NOISE DURING RUNNING HOT AIR FAN

The ovens of the Apollo structure during operation of the convection fan can be the appearance of noise.

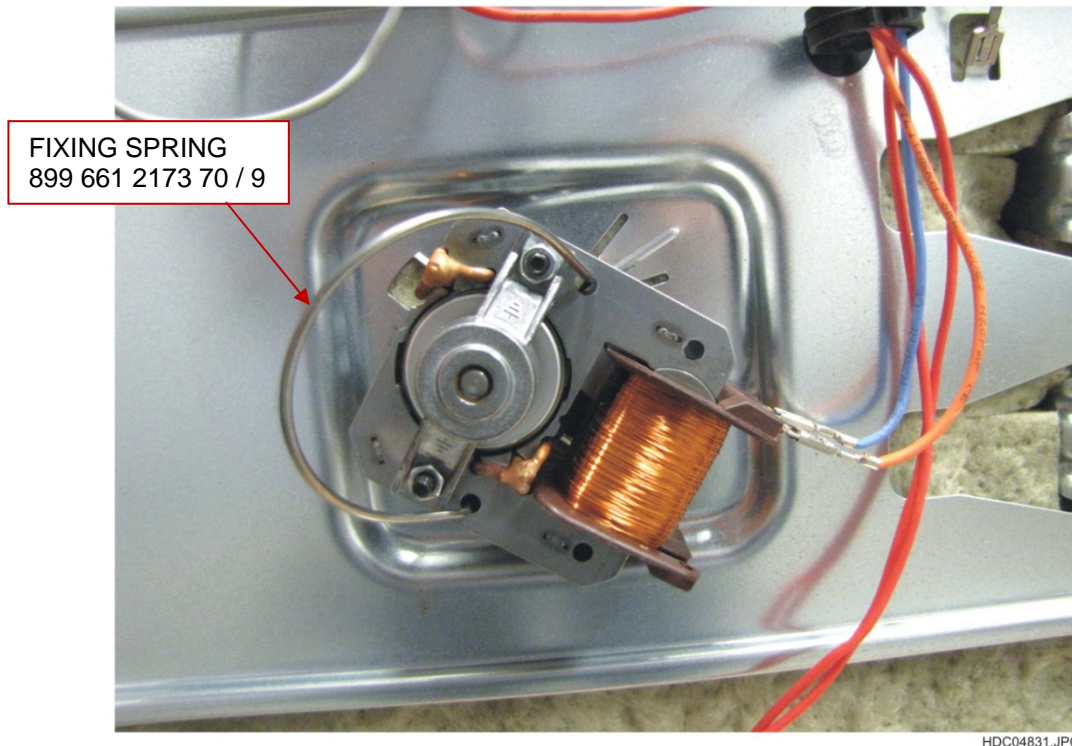
Noise by use oven functions with the hot air fan; this could be hear able from beginning or after heating up and it could be debut only a few times.

During work of the hot air motor it will be produce a magnetic field which create a vibration of the back wall. This could be hearable on different areas on the backside. But the vibrations are tactile by touching the back wall.

Do avoid the vibration of the back wall use the spring, spare part no 899 661 2173 70 / 9, and install it like described in the enclosed pictures. Use the same holes as shown on the pictures!
